<b>Docket Number:</b>	15-AFC-02
<b>Project Title:</b>	Mission Rock Energy Center
<b>TN #:</b>	215138
<b>Document Title:</b>	Data Request Response Set 2 - #132-133
<b>Description:</b>	DR Set 2 - #132-133
<b>Filer:</b>	M. Finn
<b>Organization:</b>	CH2M
<b>Submitter Role:</b>	Applicant Consultant
<b>Submission Date:</b>	1/3/2017 2:32:22 PM
<b>Docketed Date:</b>	1/3/2017

Responses to California Energy Commission Staff  
Data Request Set 2 (132 and 133)

Mission Rock Energy Center

**Figure DR132-1**  
**Natural Gas Pipeline Routes**  
 Mission Rock Energy Center  
 Ventura County, California

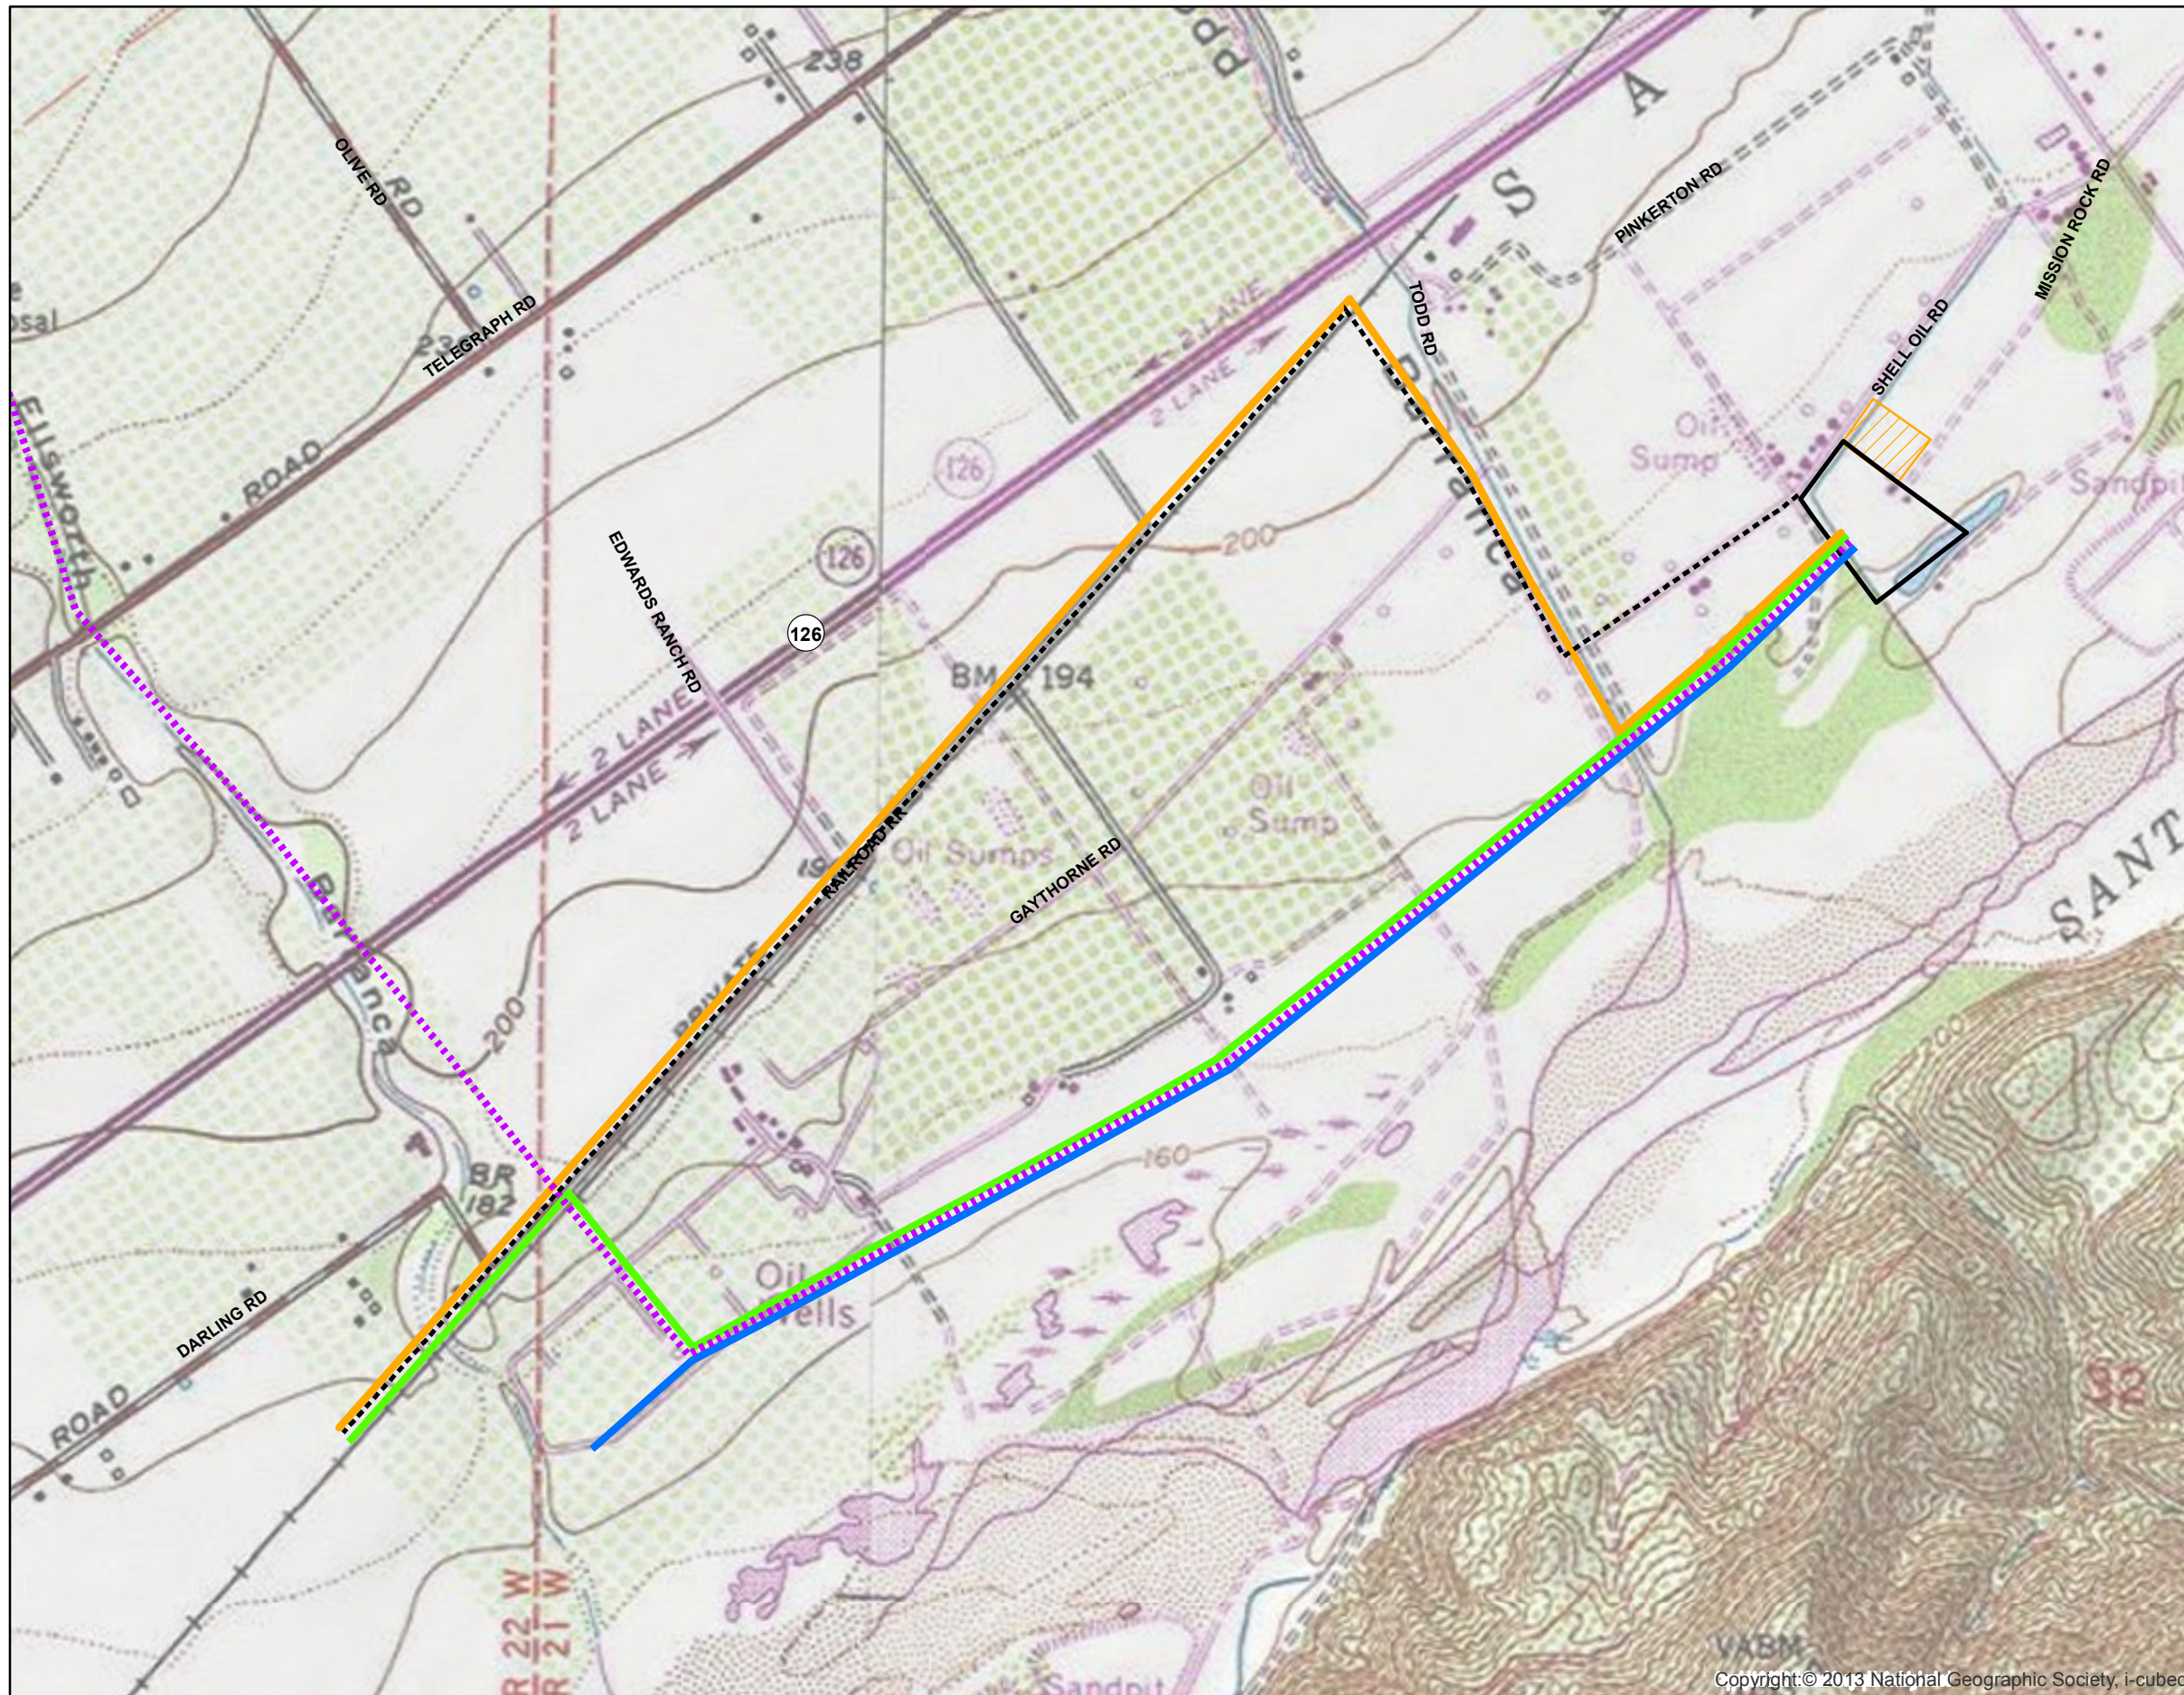
132. Please provide an assessment of two potential alternative natural gas pipeline routes:

- a. Continuation of the “railroad” route proposed in the AFC along the west side of the Todd Barranca until it meets up with the reclaimed water supply line and T-line corridor and then follow that corridor east to the power plant site. [“Route A” below]
- b. A route that would place the natural gas pipeline directly from the interconnection with SoCalGas lines 404 & 406 to the start of the reclaimed water supply line, and then following along the reclaimed water supply line and T-line corridor east to the power plant site. [“Route B” below]

**Response:** An assessment of the two natural gas pipeline routes identified by Staff is provided below. The assessment is a reconnaissance-level review focusing on potential environmental impacts. The assessment does not consider non-environmental feasibility issues. The routes are depicted in Attachment DR132-1. The routing feasibility would be determined in consultation with the Southern California Gas Company (SoCalGas), who would be responsible for design and construction of the gas facilities necessary to provide service.

- A) With Route A, beginning at the MREC site and working back to interconnection with SoCalGas lines 404 and 406, the natural gas pipeline would enter the project site in the same right-of-way as the generator tie-line and recycled water pipeline and would cross Todd Barranca in this same right-of-way, instead of following Shell Road to a separate crossing of the Barranca. All of the Route A rights-of-way have been previously surveyed for biological and cultural resources except for approximately 625 feet of pipeline route between the existing Todd Barranca gas pipeline crossing point shown in the AFC and the Route A crossing point for the natural gas pipeline, recycled water line, and generator tie-line. This 625-foot section has been evaluated for biological resources and considered for cultural resources at a general level and for cultural resources of the built environment, but has not be subject to pedestrian surveys for archaeological resources. Based on the surveys that have already been conducted, potential environmental effects would be similar to those previously described for the natural gas pipeline, recycled water pipeline, and generator tie-line. Route A would be 2.58 miles long. It would require revised right-of-way agreements for the existing right-of-way to accommodate a natural gas pipeline and a new right-of-way agreement for the 625-foot-long segment that was not part of any of the existing right-of-way agreements.

- B) With Route B, the natural gas pipeline would also enter the project site in the same right-of-way as the recycled water pipeline and generator tie-line, instead of following Shell Road to Todd Barranca. Where the generator tie-line turns north and departs from the recycled water pipeline, Route B would also turn north, following the generator tie-line route as far as the railroad right-of-way. Route B would then turn to the west-southwest along the railroad right-of-way to the point of interconnection with SoCalGas lines 404 and 406. All of the Route B right-of-way has been previously surveyed for cultural and biological resources. Potential environmental effects would be the same as previously described for the natural gas pipeline, recycled water pipeline, and generator tie-line. Route B is approximately 2.14 miles long. It would require revised right-of-way agreements for the existing rights-of-way to accommodate a natural gas pipeline.
